Product/Process Change Notice (PCN)

PCN Number: PCN_ConCARD_20250624 Affected Series: WR-COM Affected Part Number: 693063020911 PCN Date: 2025-03-24 Effective Date: 2025-06-24	Change Category: ☐ Equipment/Location ☒ General Data ☐ Material ☐ Process ☐ Product Design ☒ Shipping/Packaging ☐ Supplier ☐ Software
Contact: Product Management Phone: +49 (0) 7942 - 945 5001 Fax: +49 (0) 7942 - 945 5179 E-Mail: pcn.eican@we-online.com	Datasheet Change: ☒ Yes ☐ No Attachment: ☐ Yes ☒ No

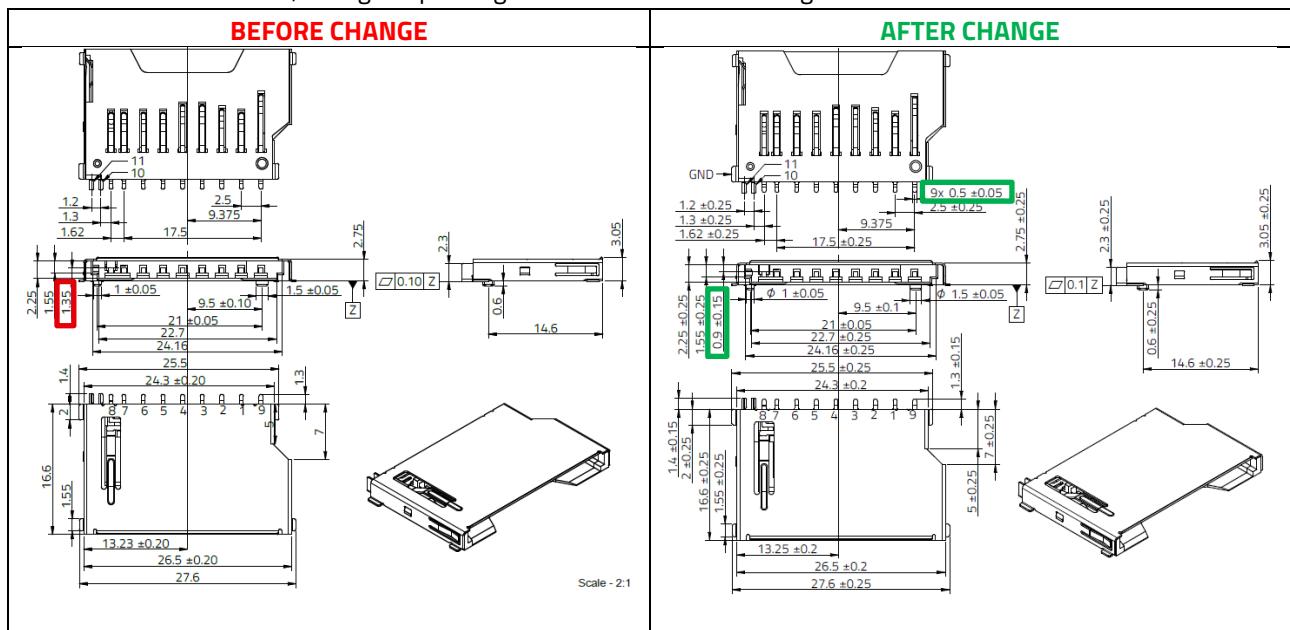
In order to better comply with industry standards, Würth Elektronik eiSos is improving the technical drawing to match with required SD card standard thickness. To improve quality control, the packaging of the affected part number will be changed from opaque to transparent in order to facilitate automated check.
